Wisconsin Department of Transportation

Proposal #21: 4996-01-58, WISC 2015 144
Taylor Drive, City of Sheboygan
Kohler Memorial Dr – Crocker Ave
Local Street
Sheboygan County

This is Addendum No. 02, which provides for the following:

ADDENDUM NO. 02

Addendum No. 02
 ID 4996-01-58
 Revised Sheet 59
 November 3, 2015

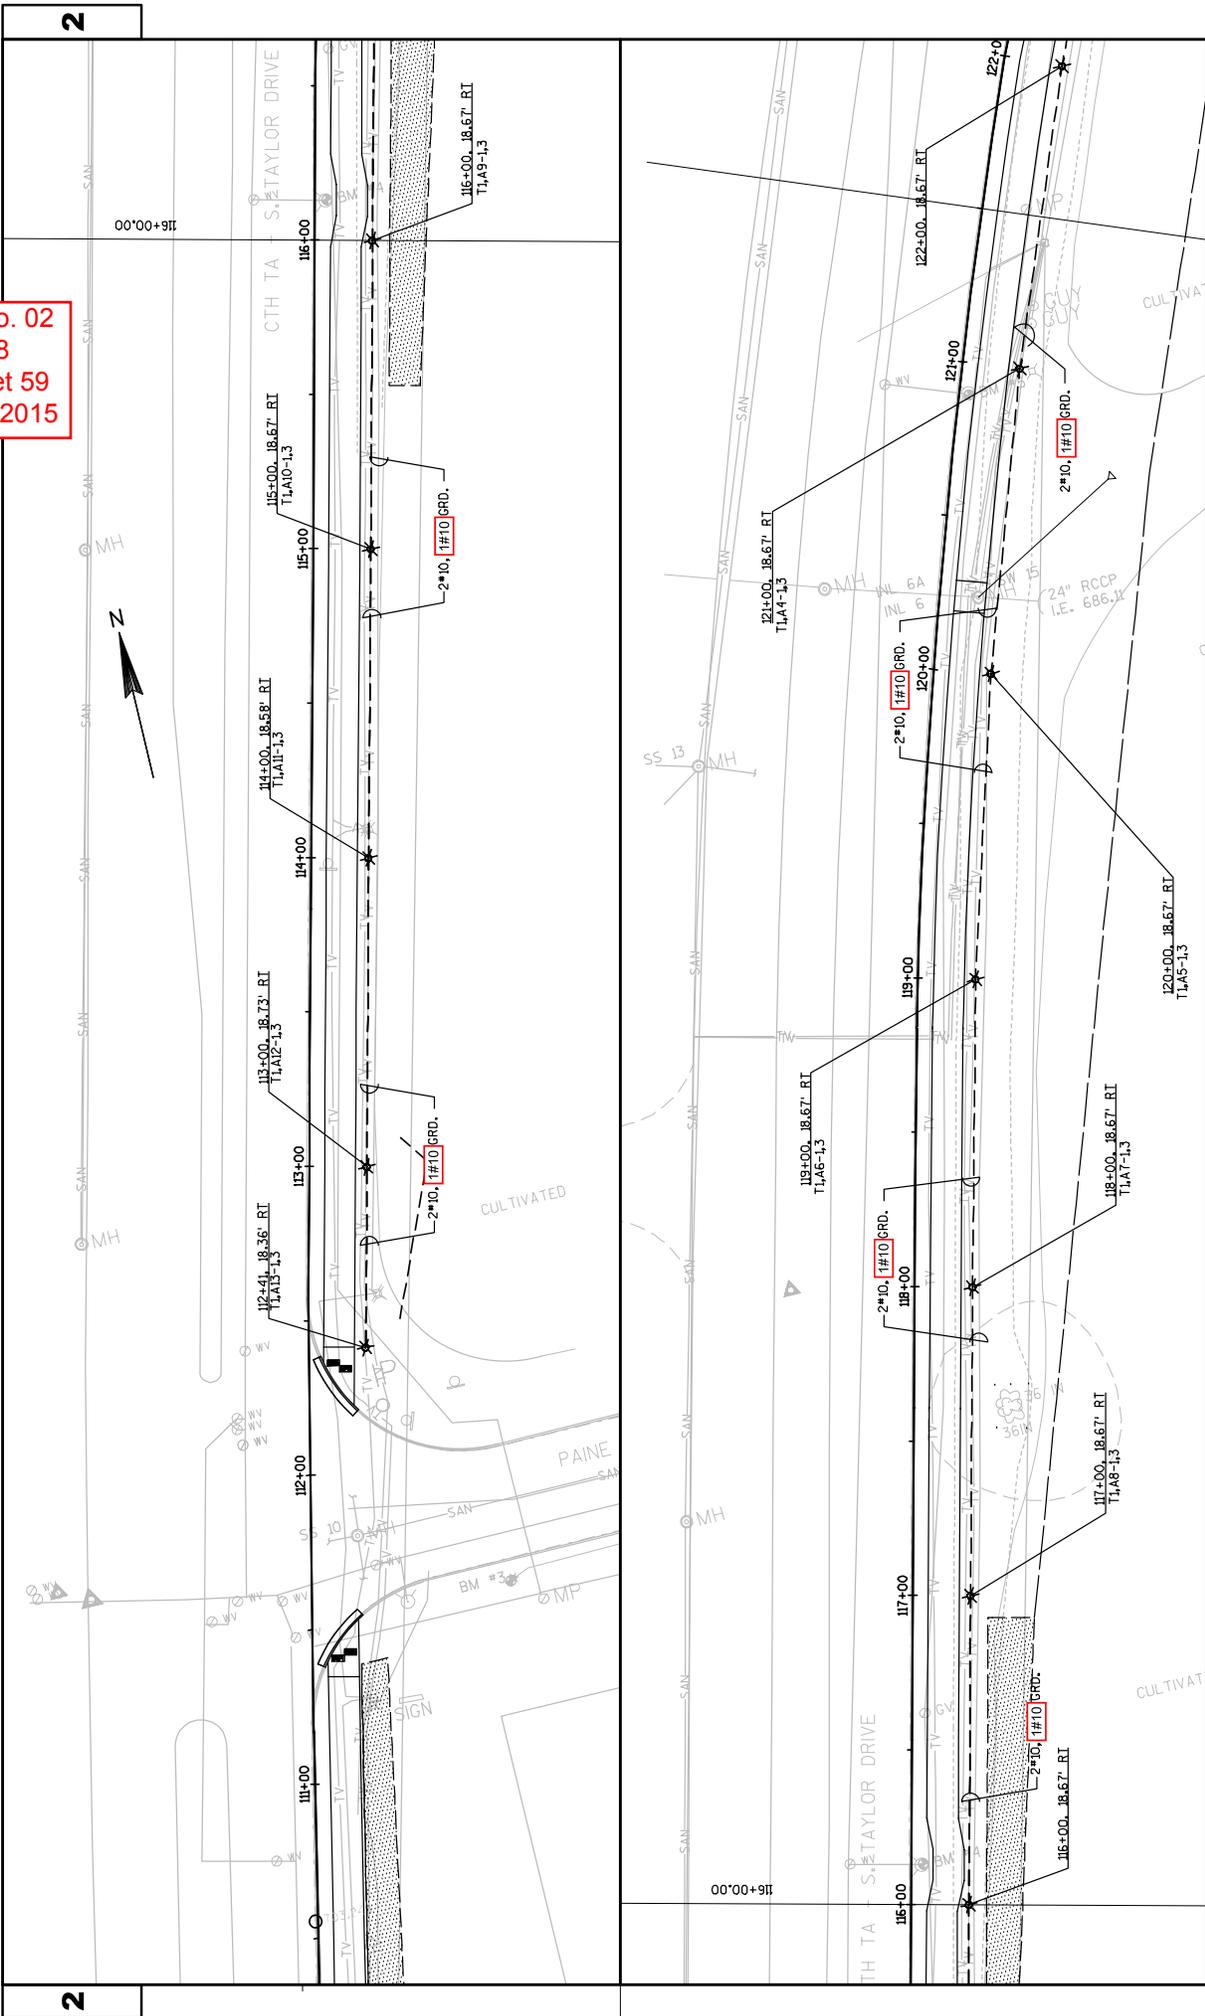
Revised Plan Sheets	
Plan Sheet	Plan Sheet Title (brief description of changes to sheet)
59-66	Lighting Plans (changed ground wire size)
119	Miscellaneous Quantities (changed traffic control items)
121	Miscellaneous Quantities (changed conduit size from 1 ¼-inch to 2-inch, and ground wire size)
123	Miscellaneous Quantities (noted additional quantity shown elsewhere for 2-inch conduit)

Addendum No. 02
 ID 4996-01-58
 Added Sheet 96A
 November 3, 2015

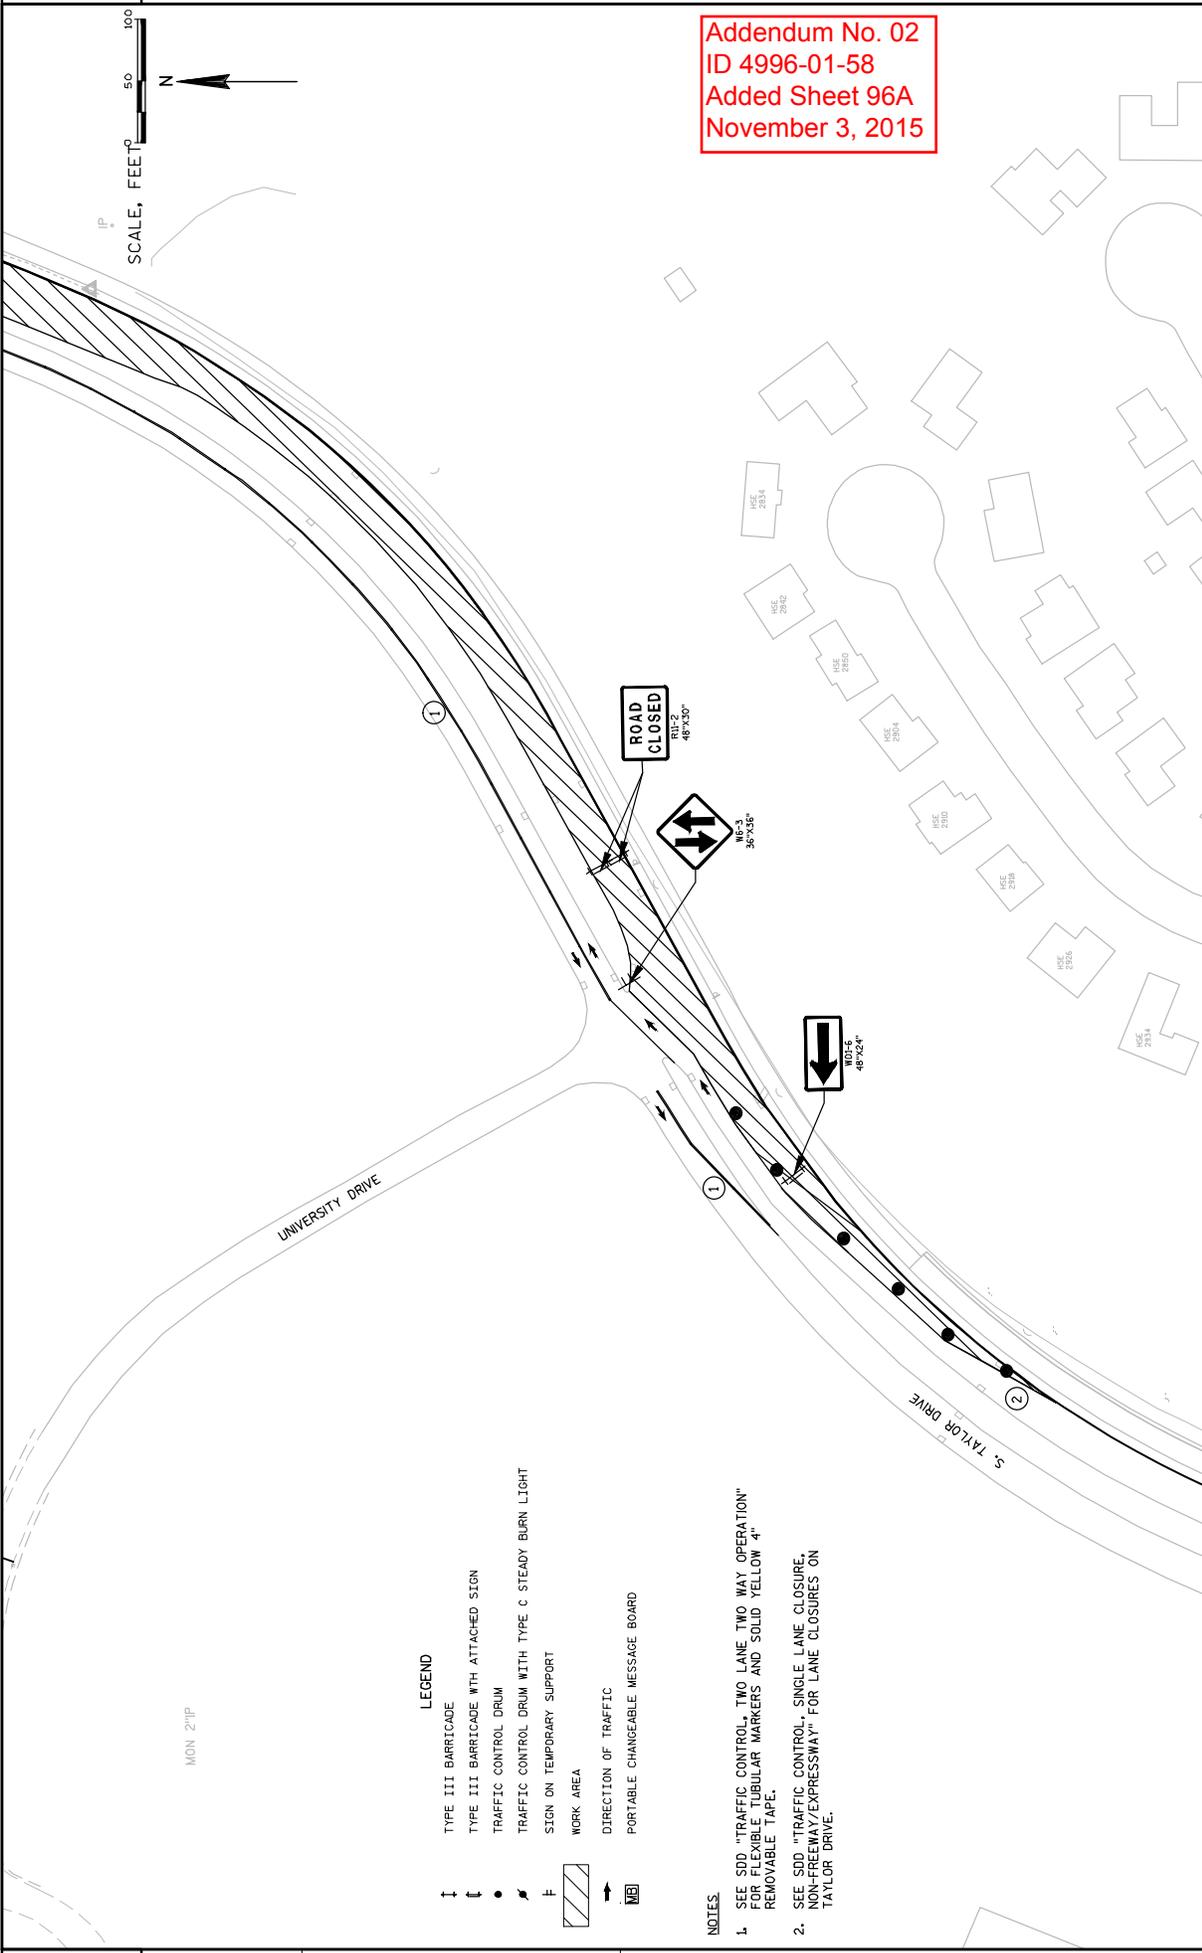
Added Plan Sheets	
Plan Sheet	Plan Sheet Title (brief description of changes to sheet)
96A-96C	Traffic Control Bridge Erection Stage (3 sheets)
218A	SDD15D6-3 Traffic Control, Two Lane Two Way Operation

All northbound Traffic will be shifted to the east southbound lane between University Avenue and New Jersey Avenue for the erection of the prefabricated truss bridges B-59-188 and B-59-189. The traffic can be shifted for no more than two consecutive calendar weeks.
